Prepared for:
Macquarie University
Date:
25 September 2018

Response to Submissions

Macquarie University Central Courtyard Precinct

Section through C10a – Floor ceiling clearances measure from 2400 to 2600mm

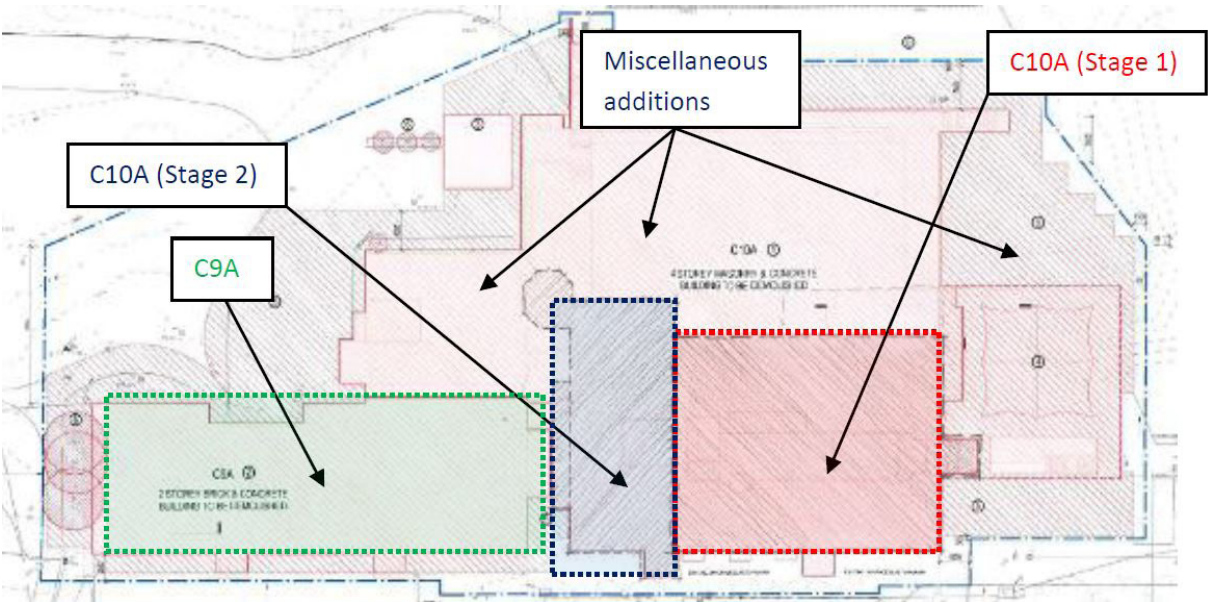
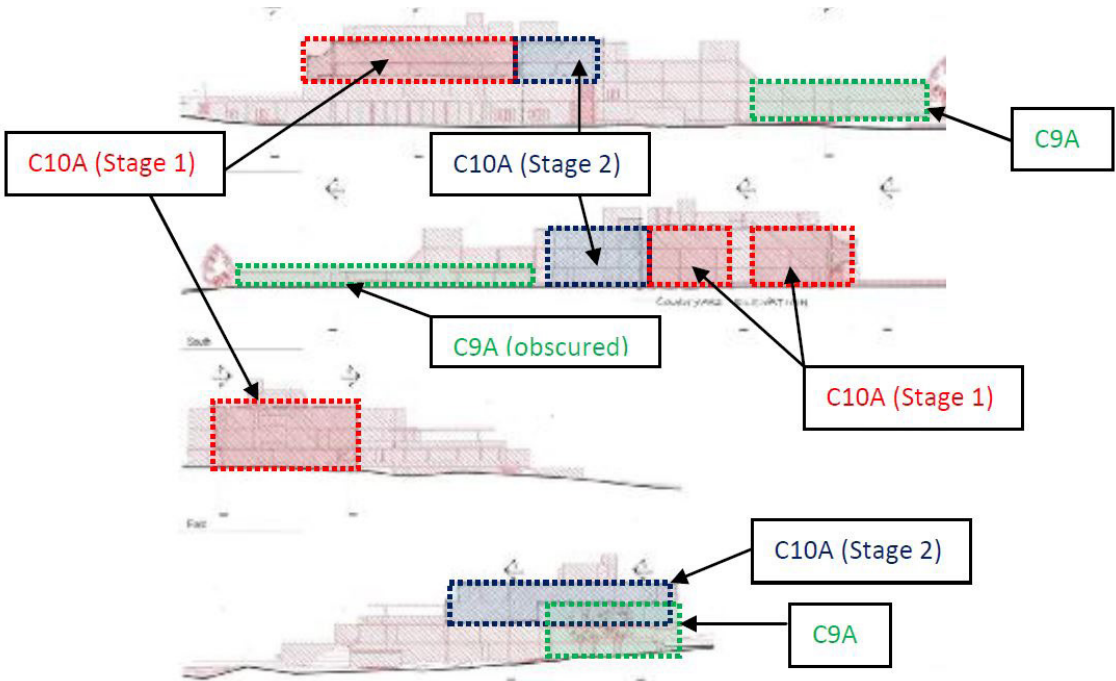
Options for the retention of the existing building (eg combined with infill development), should have been considered and included in the EIS.

Buildings C9a and C10a had multiple additions and limited floor to floor heights not suitable to contemporary teaching and learning practices.

The proposed floor to floor heights in the 1CC building is 4.6m and 4.7m. This strategy for generous internal clearances establishes inherent flexibility in the building fabric to accommodate a diverse range of contemporary teaching modalities and technologies with large format digital projection.

Right: Shadow diagrams for SSDA submission

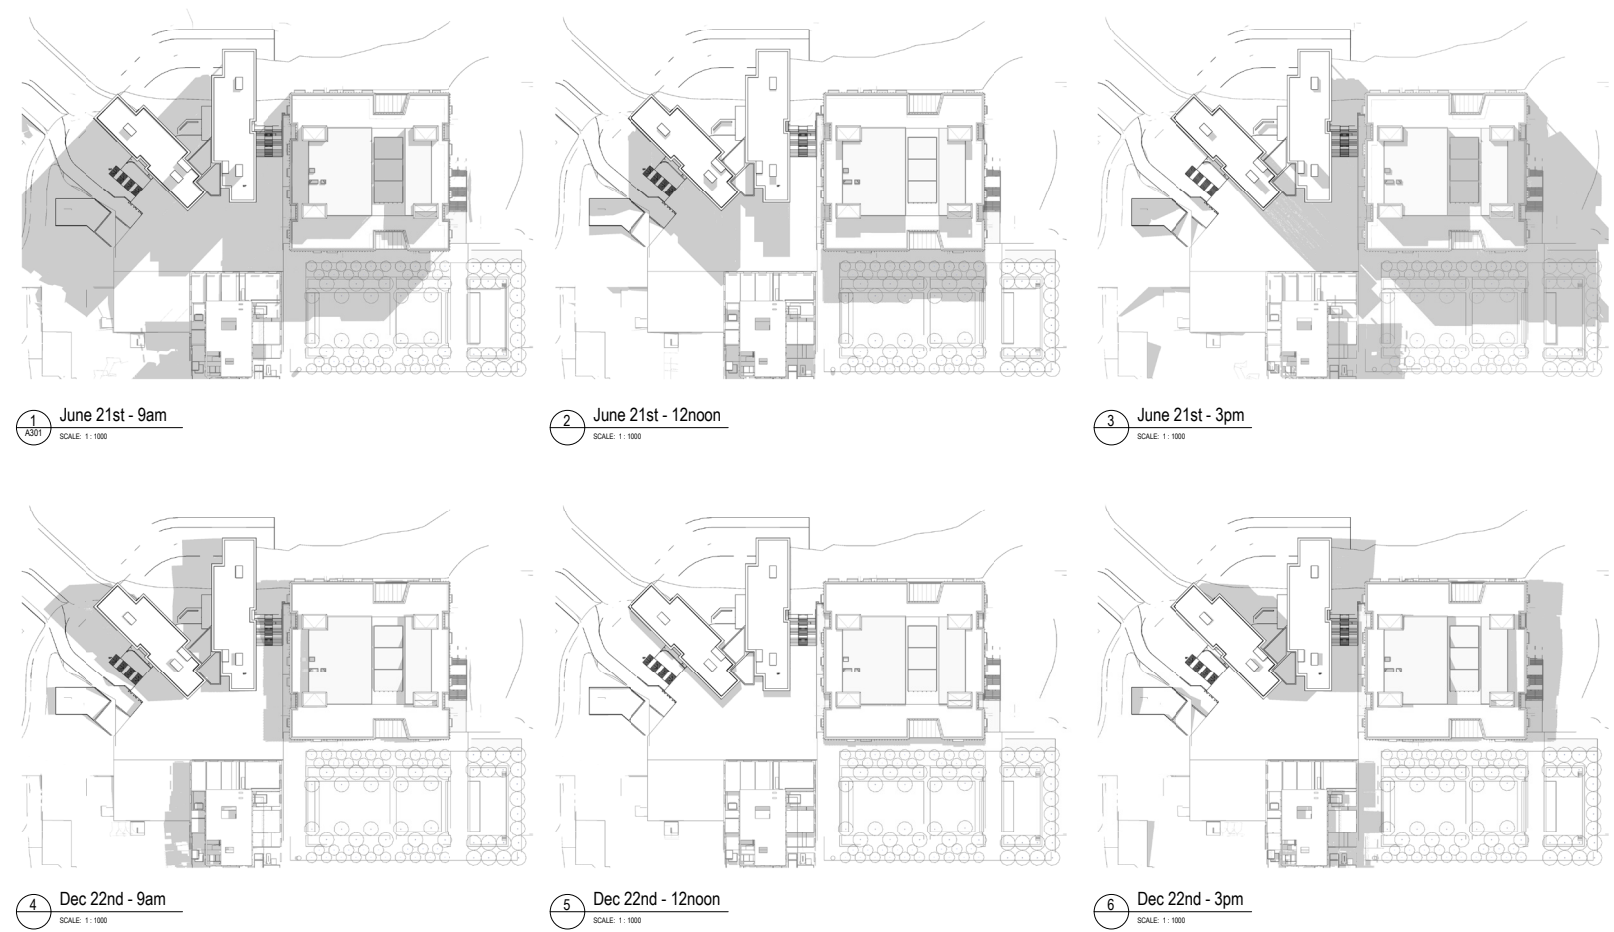
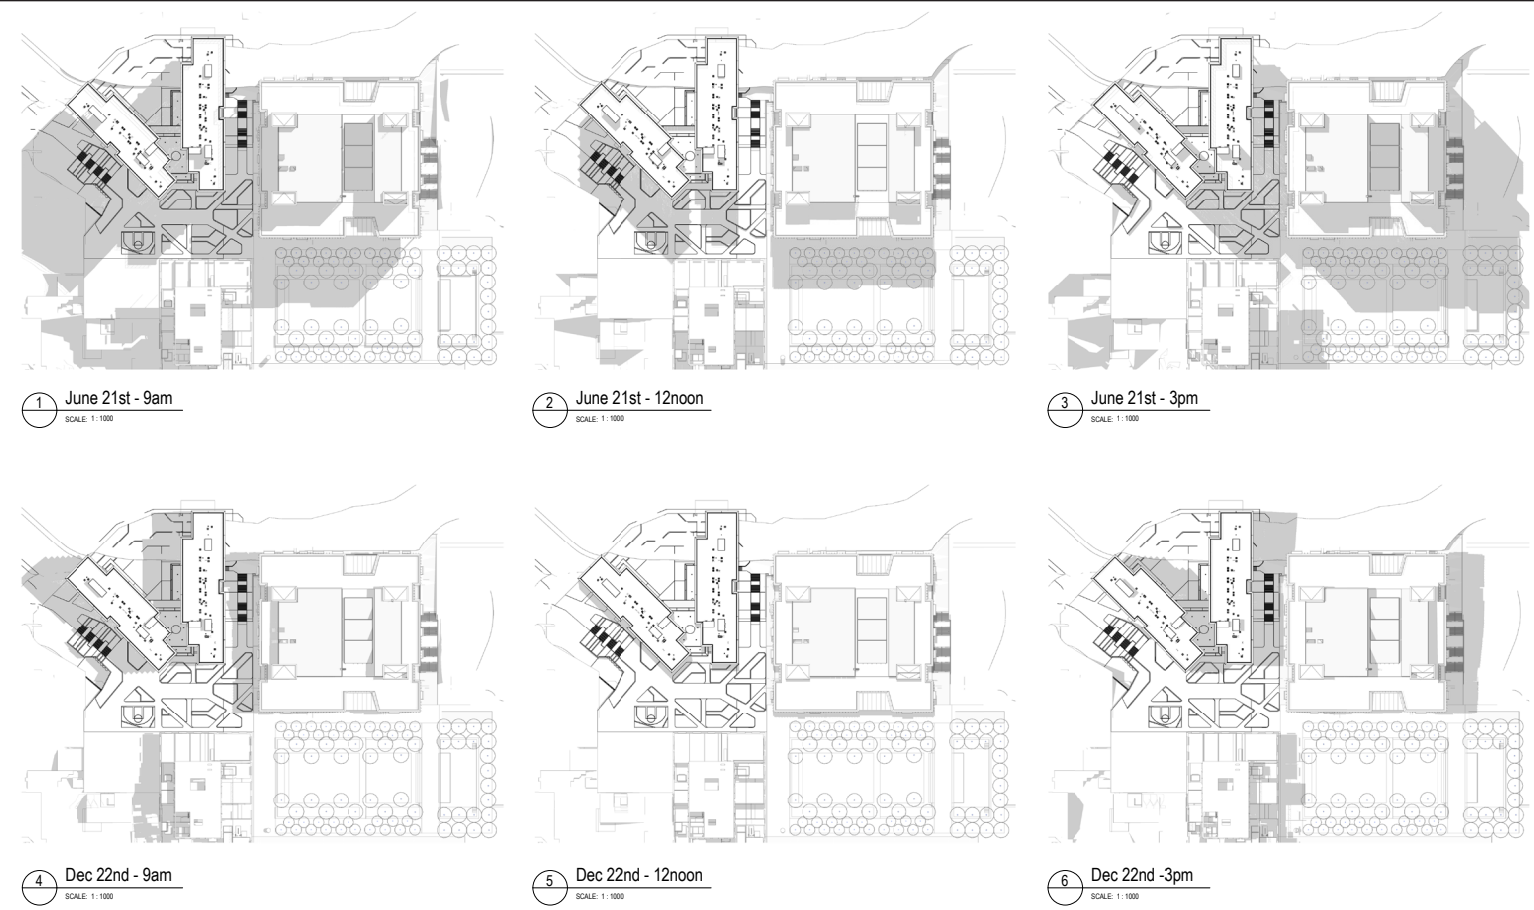
The student forecourt south of R1 and R2 will have little amenity because it is partially overshadowed by buildings to the north.

A floor level of accommodation has been removed from R2 in the revised design, reducing its overall height by 3100mm, with a minor reduction to overshadowing. However, the primary function of the student forecourt is as a transitory experience along a pedestrian path connecting the Central Courtyard to Gymnasium Road. This forms a western entry into the campus. The project provides multiple opportunities for access of sunlight.

Section F: Student Courtyard

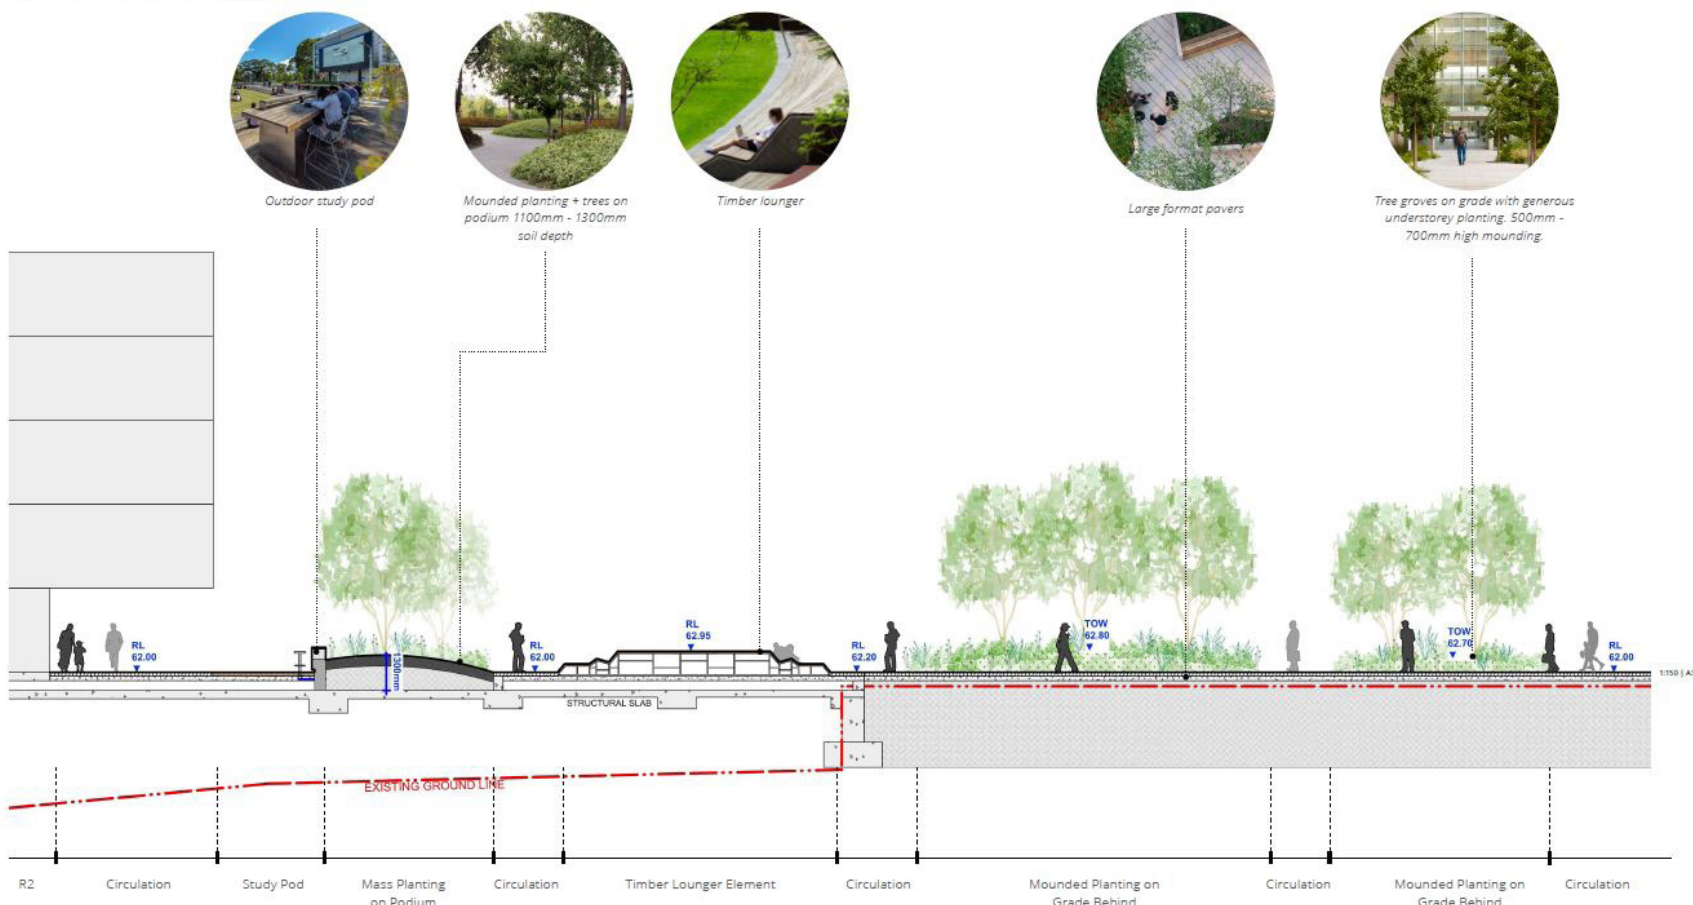
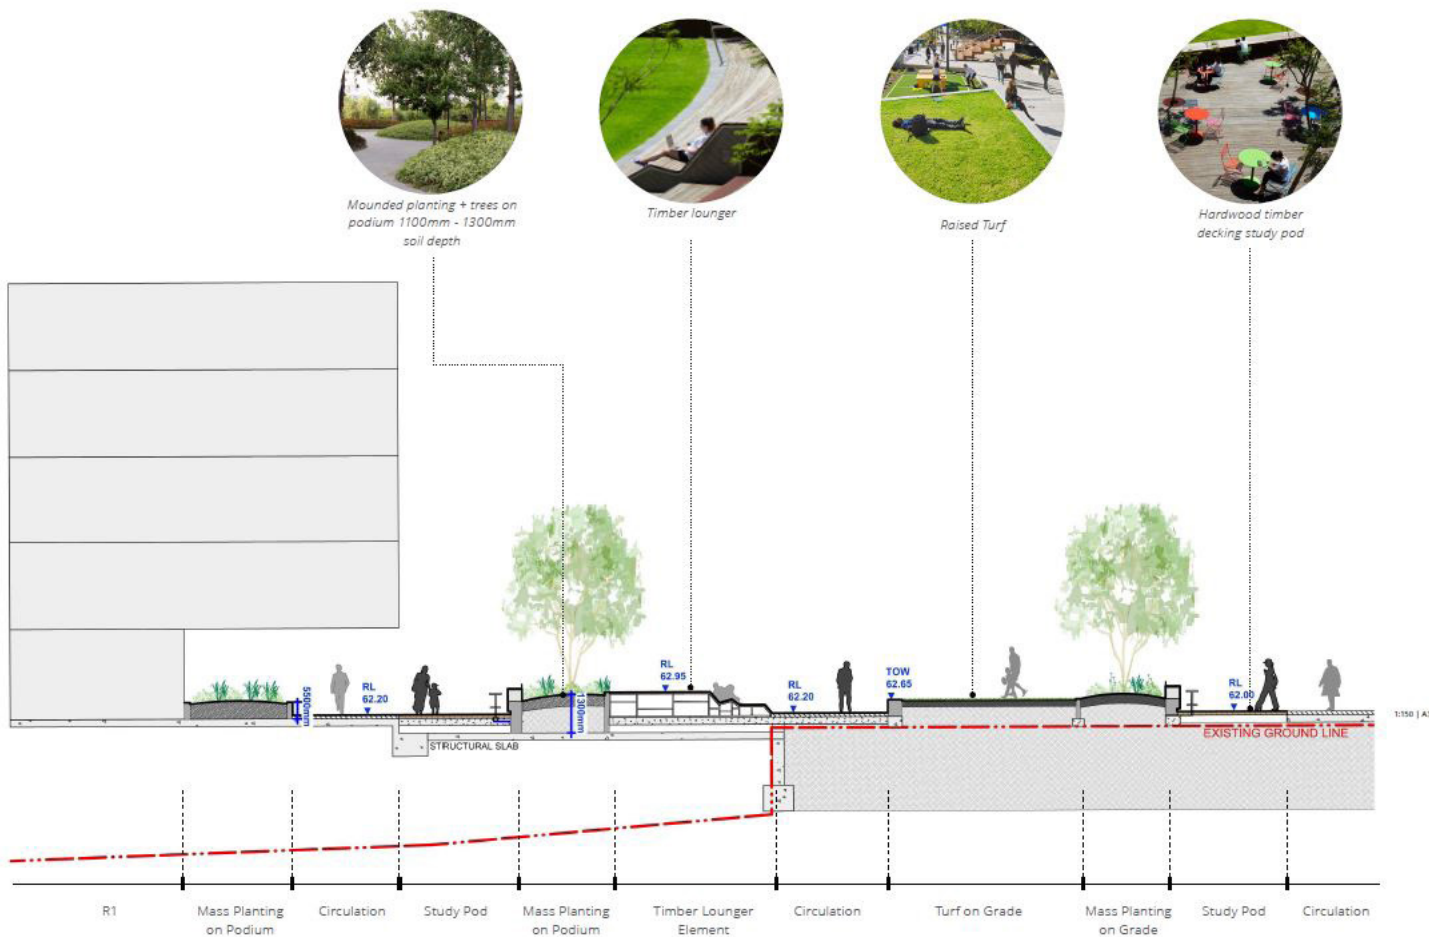
Planting beds in the student courtyard are proposed to provide 1,000mm of soil depth, but this has not been shown in architectural or landscape drawings. The deep soil is essential to support good tree cover that could provide shade and mitigate possible wind turbulence.

Aspect Studios has documented soil depths in planter beds of 1100mm to 1300mm. Refer to subsequent diagrams.

Above: Revised roof plan with separation from plant and linear clarity to the skylight

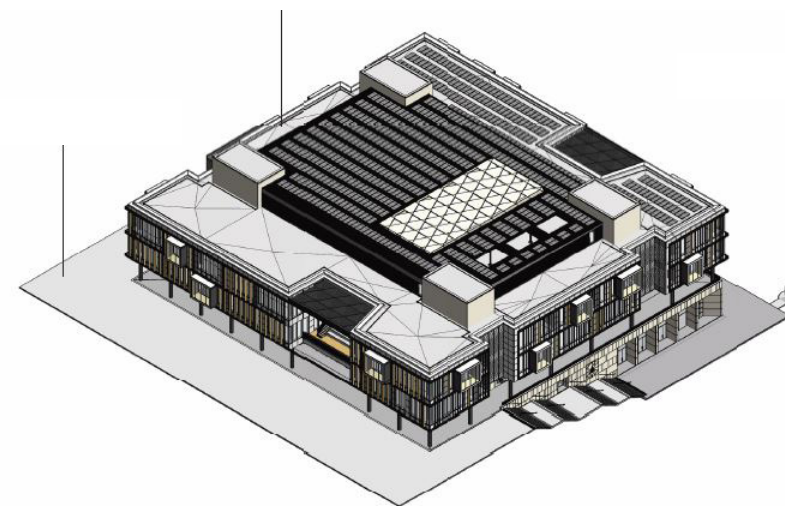
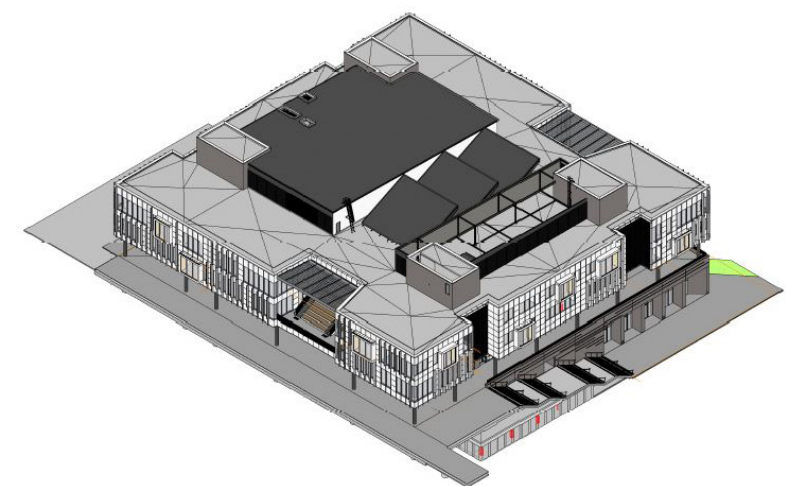
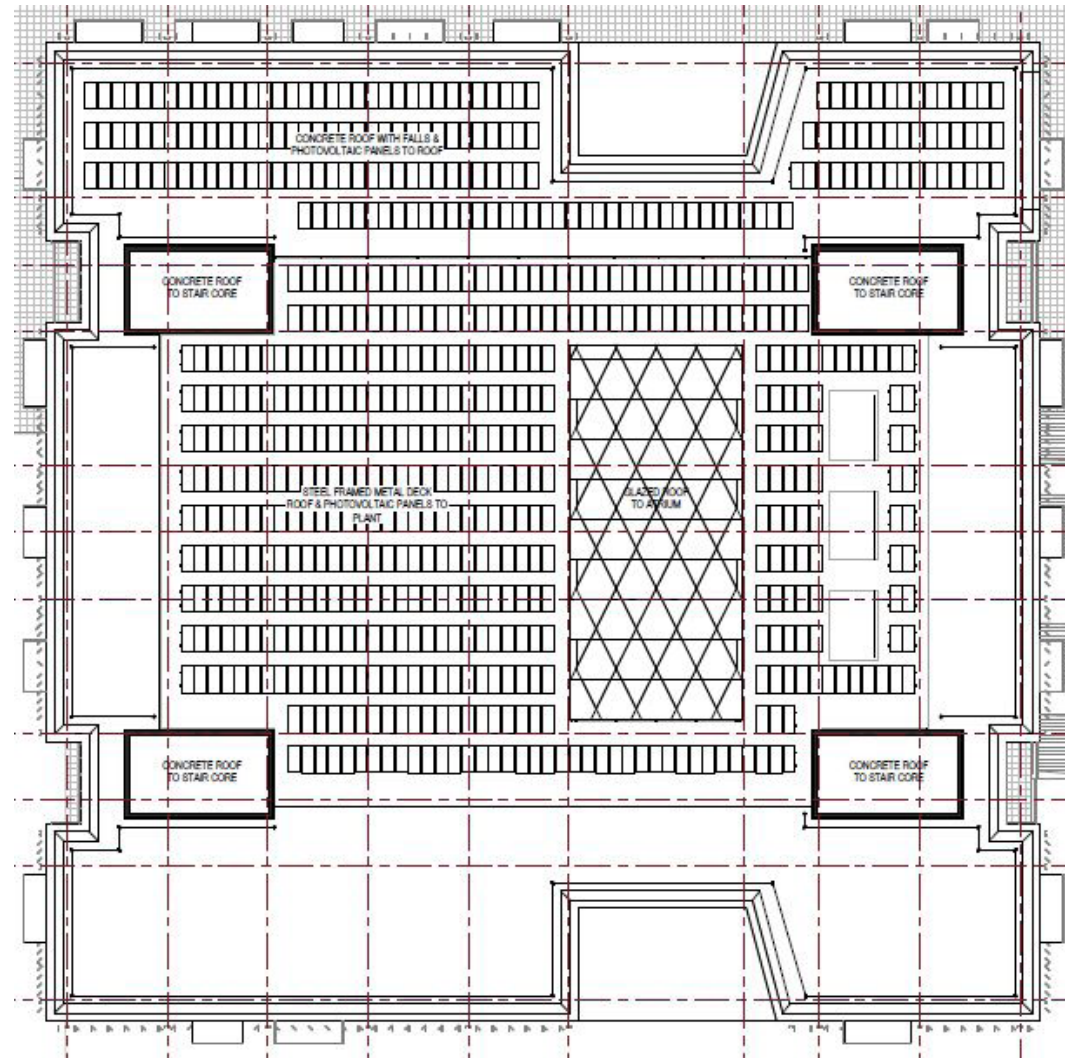
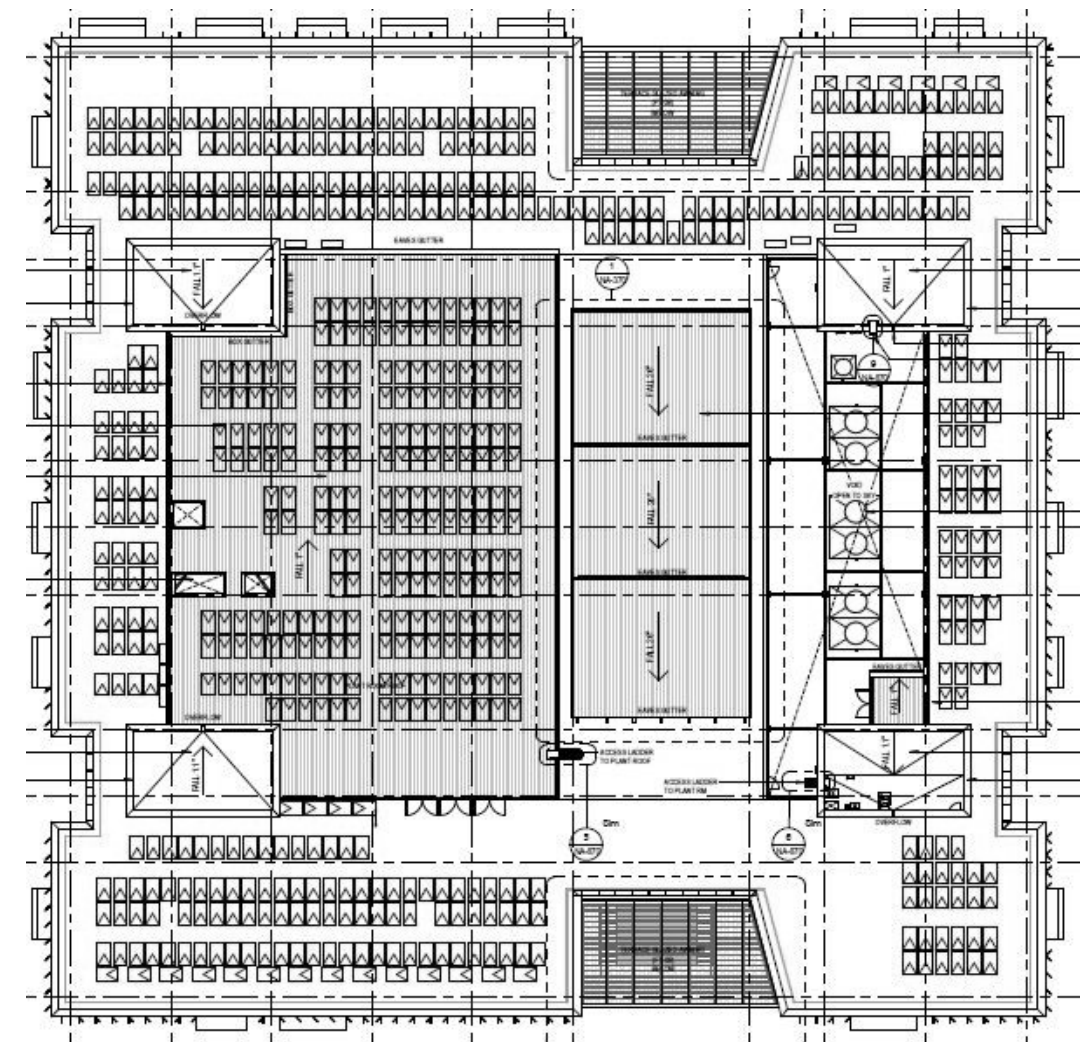
The bulk of the new ICC building, with a footprint exceeding 70m in both directions, is larger than a typical CBD block. The architectural strategy to articulate the plan around the atrium has not been entirely successful due to the impact of rooftop plant which dominates the upper levels of the building. Consideration could be given to applying the same strategies to articulating the roofline of this very large building.

The roof line of 1CC has been adjusted to give greater clarity to the skylight as a separate element to the building's plant spaces. The roof plant is positioned as in-set from the 1CC perimeter envelope which reduces its apparent scale and makes less visible from surface level, as such it does not dominate the upper levels of the 1CC Building.
